Document ID: IK1201270

Title: Interstage Cooler Interference With Valve Cover Sound Shield Mounting Bolts

Applies To: EPA 2013 HD-OBD and later DT/9/10 and N9/N10

Figure 1: Example of interference

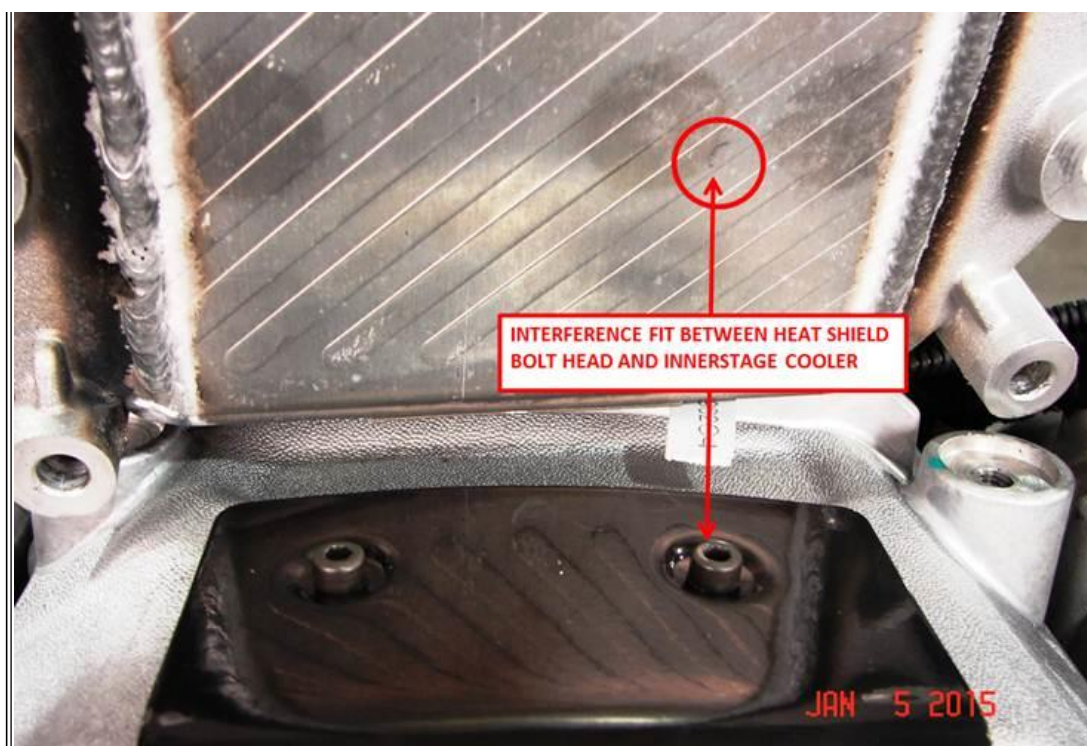
There are incidents of contact between the bottom panel of the interstage cooler and the valve cover sound shield mounting bolt on High Torque and SCR equipped medium duty engines. The current socket head screw could cause interference issues between itself and the interstage cooler. This document reviews the concern and repair steps for assembling with button head screws.

1. Install four button head cap screws to heat shield.
2. Install a new 2.62 x 61.6 ID O-ring in groove on HP turbocharger.
3. Attach turbocharger inlet elbow to HP turbocharger with V-band clamp. Do not fully tighten V-band clamp at this time. Allow turbocharger inlet elbow to rotate as necessary to allow for ISC to be installed.
